HISTORIC AND DESIGN REVIEW COMMISSION

December 21, 2022

HDRC CASE NO: 2022-577
ADDRESS: 305 LAVACA ST
LEGAL DESCRIPTION: NCB 708 BLK 8 LOT 2 (305 LAVACA TOWNHOUSES)
ZONING: RM-4, H
CITY COUNCIL DIST.: 1
DISTRICT: Lavaca Historic District
APPLICANT: Tim Rodgers/South Flores Construction
OWNER: Tony Pearson/305 LAVACA TOWNHOUSES
TYPE OF WORK: New construction of two 2-story duplex structures
APPLICATION RECEIVED: December 05, 2022
60-DAY REVIEW: Not applicable due to City Council Emergency Orders
CASE MANAGER: Rachel Rettaliata

The applicant is requesting conceptual approval to construct two, 2-story duplex structures at 305 Lavaca.

① FRONT ELEVATION- SOUTH
SCALE: 1/4" = 1'-0"

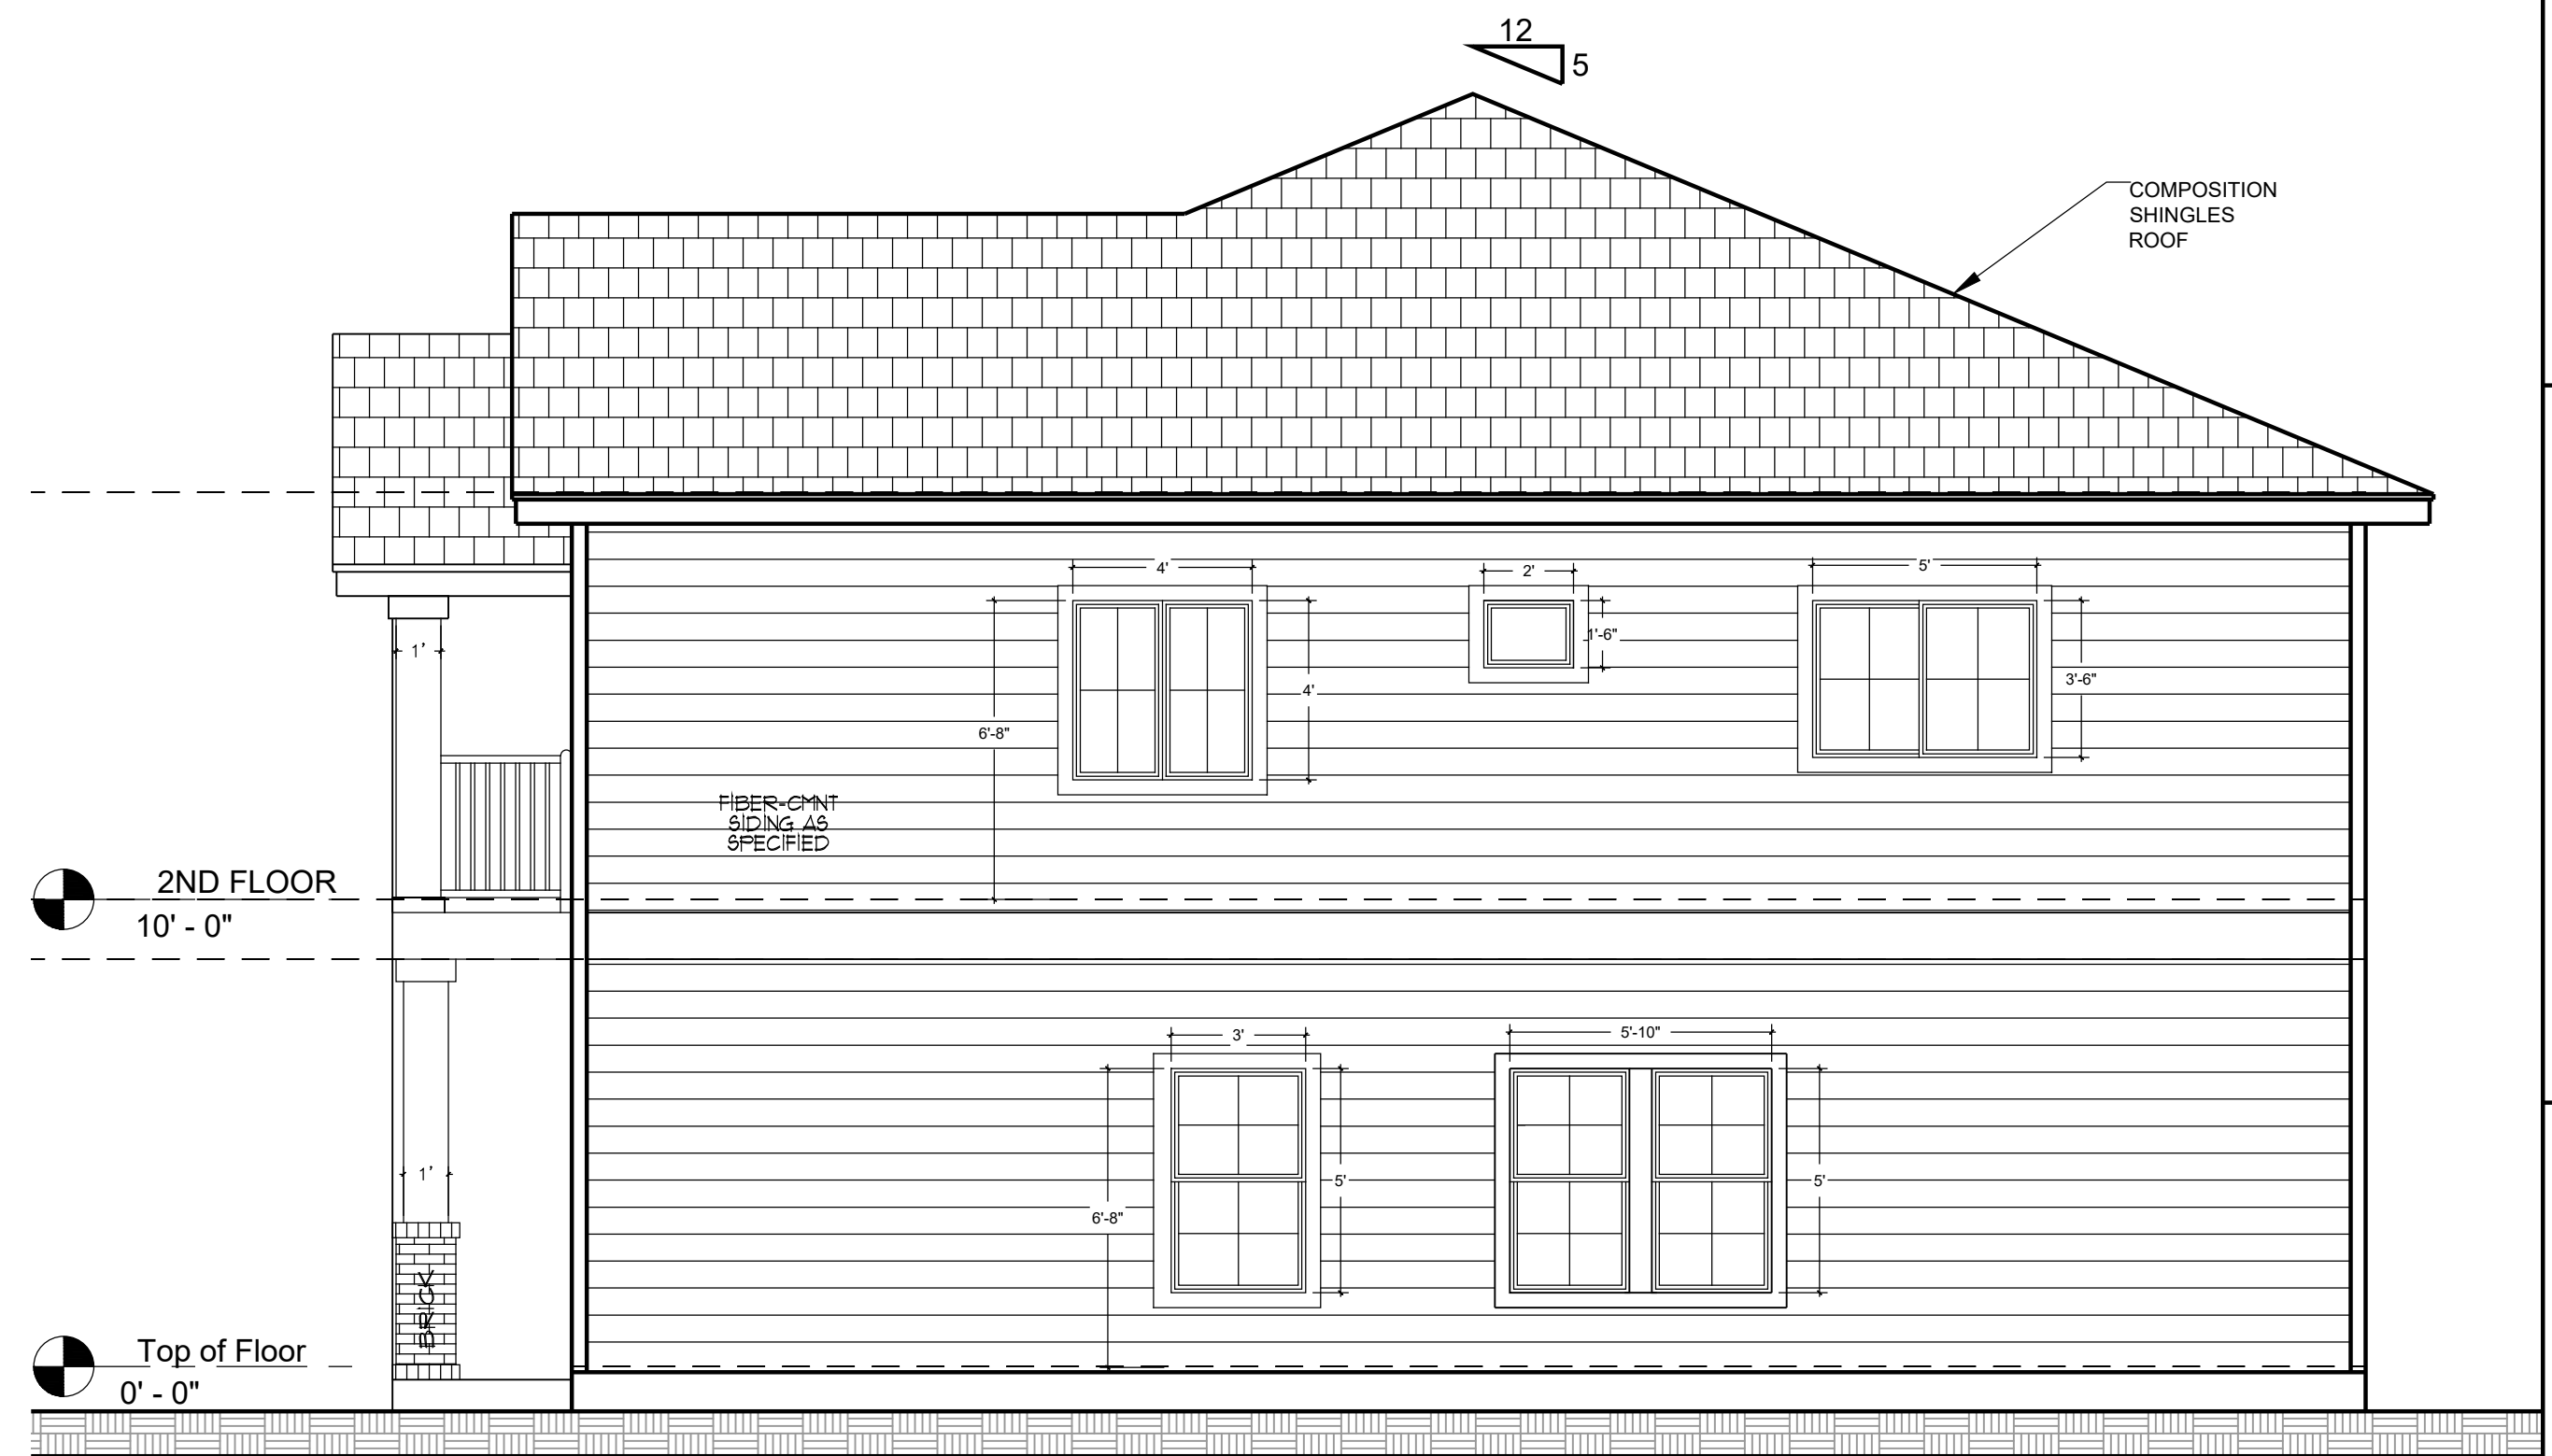
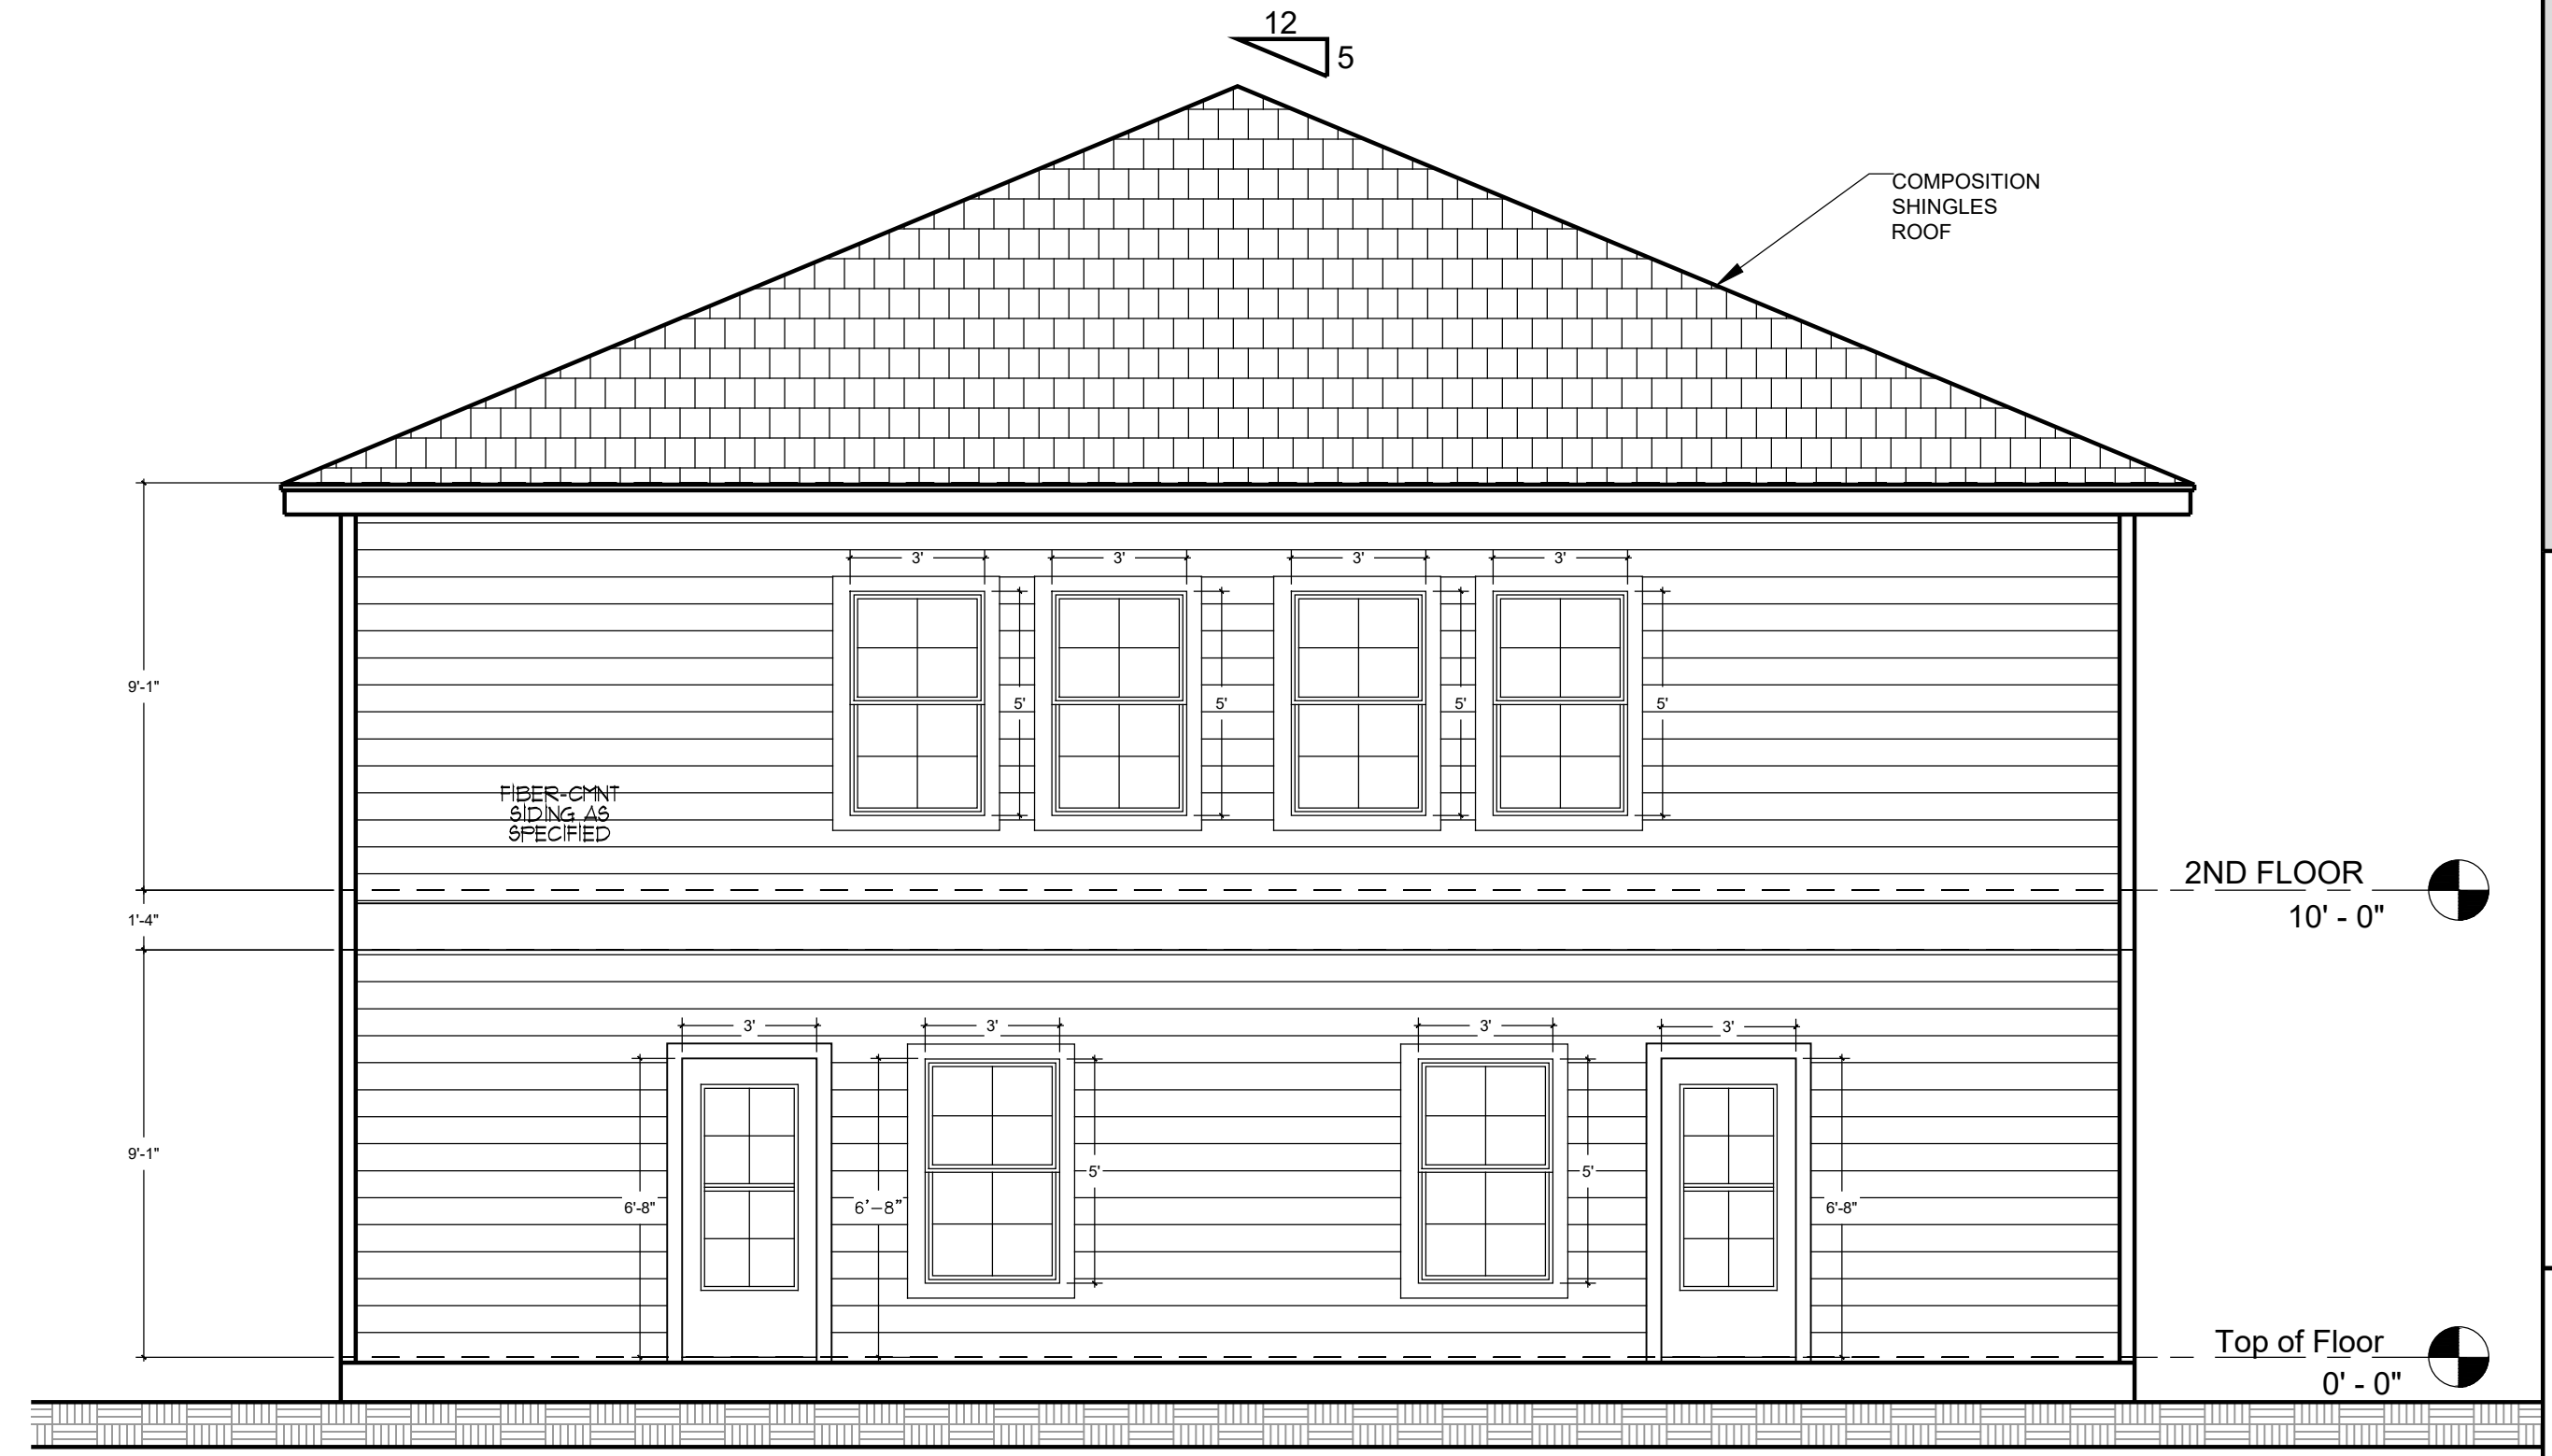
LG: I have a design question related to the front elevation and the brick base on the columns. The brick base is something that you may see on a Craftsman home and the columns are more Neo-Classical in style.
